Monterey Bay Aquarium Research Institute 7700 Sandhold Road, Moss Landing, CA 95039	
		Title Squirty: Controller	
Engineer Paul McGill	Size A	Document Number <Doc>	Layout File Rev 1.1.1
Date: Monday, December 12, 2022		Sheet 1 of 1

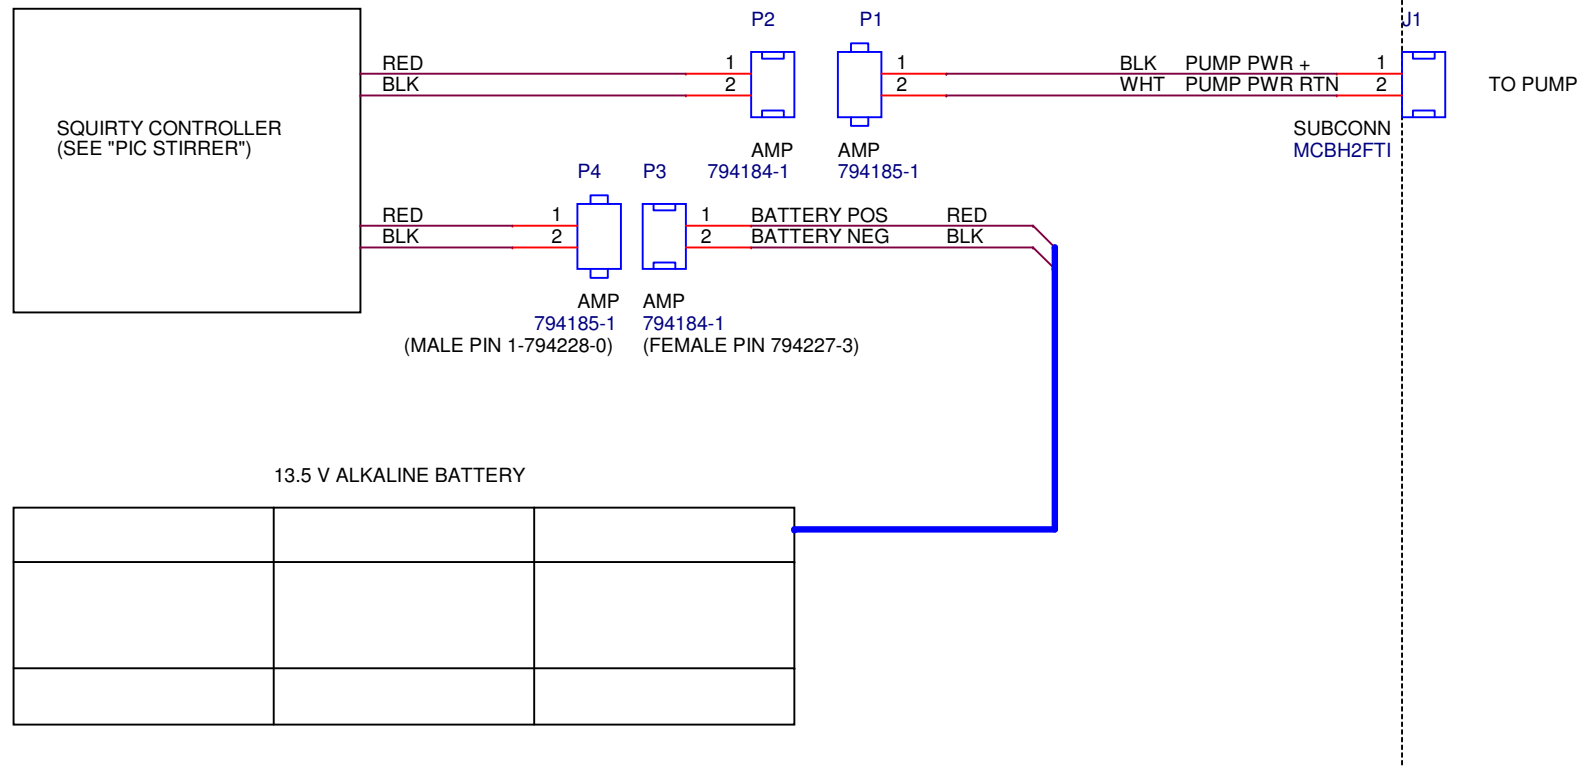
NOTE: PIC STIRRER MODIFIED FOR USE AS SQUIRTY
CONTROLLER BY REPLACING THE FOLLOWING PARTS:

- 1) U1 REPLACE LT1129CST-3.3 WITH LM2936MP-3.3
- 2) U2 REPLACE PIC10F222 WITH PIC10LF322

CHANGE LOG
v1.0.0 INITIAL RELEASE
v1.1.0 CHANGED SEX OF 2-PIN CONNECTORS
v1.1.1 CHANGED TITLE BLOCK
